भारत सरकार - रेल मंत्रालय  
अनुसंधान अभिकल्प और मानक संगठन  
लखनऊ - 226011  
Government of India - Ministry of Railways  
Research, Designs & Standards Organization,  
LUCKNOW - 226011

**MODIFICATION SHEET NO. RDSO/2012/EL/MS/ 0407 (Rev.0) , Dated**  
**29.02.2012**

Standardization of power selection switch position in flasher units provided in three phase electric locomotives.

FIG.-I

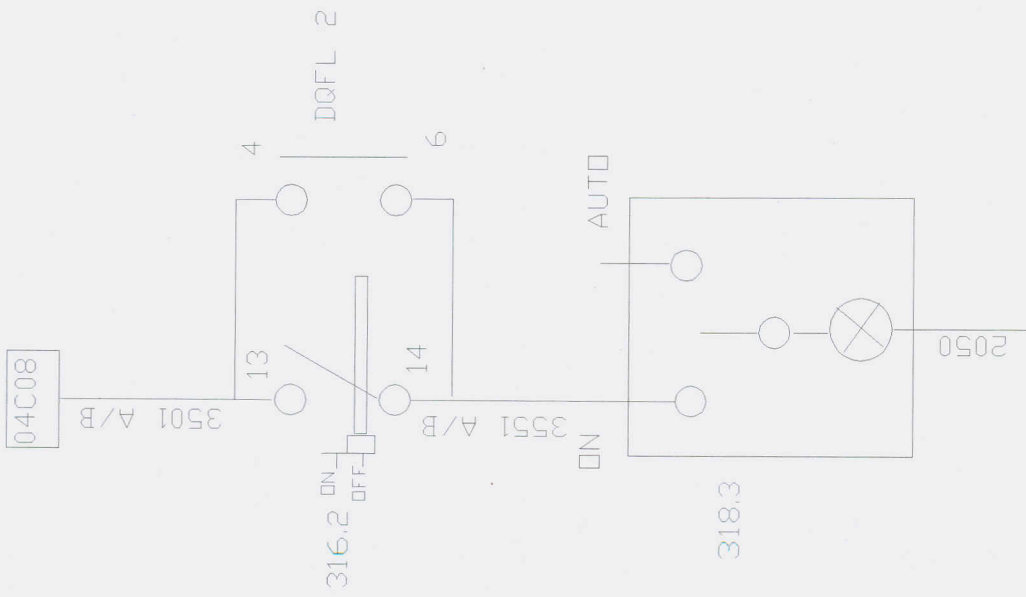
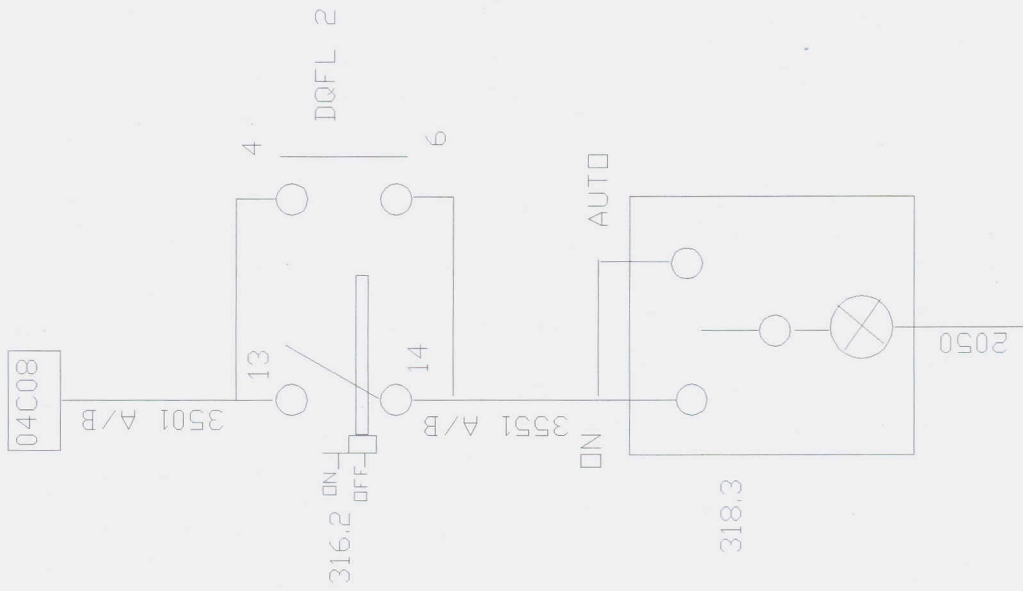
In a flasher (FL) unit (provided as per RDSO specification no. ELRS/SPEC/LFL/0017 Rev.'1'), there are two positions in the power selection switch, one is 'Auto' and the other 'ON' position. Such FL units are used in both conventional locos and in 3-phase locos.

In the FL units used in conventional locos, the power selection switch is kept in 'Auto' mode during train working and in 'ON' mode for manual operation during testing of the FL unit. But in 3-phase locos the power selection switch is kept only in 'ON' mode both for train working and also for manual operation/testing of FL unit as BPFL switch provided on driving desk is to be kept in 'ON' position for manual operation . The FL unit get isolated in 3-phase locos if the power selection switch is kept in 'Auto' position.

The above situation is creating confusion to the running staff particularly while working 3-phase locos. If inadvertently, the power selection switch is kept in 'Auto' position by the running staff in 3-phase locos, the FL unit will get isolated and will result in loco failure.

As per ABB doc. No. 3EHP281144 sheet no. 04C, 3EHP281147 sheet no 07D of G1. The circuit diagram is indicated as Fig.-I .

A loop of 2.5mm<sup>2</sup> cable of approximately 10 cm to be connected between Auto and ON terminal at terminal board provided on flasher control unit in each cab.

The modified circuit diagram is indicated in Fig.-II.
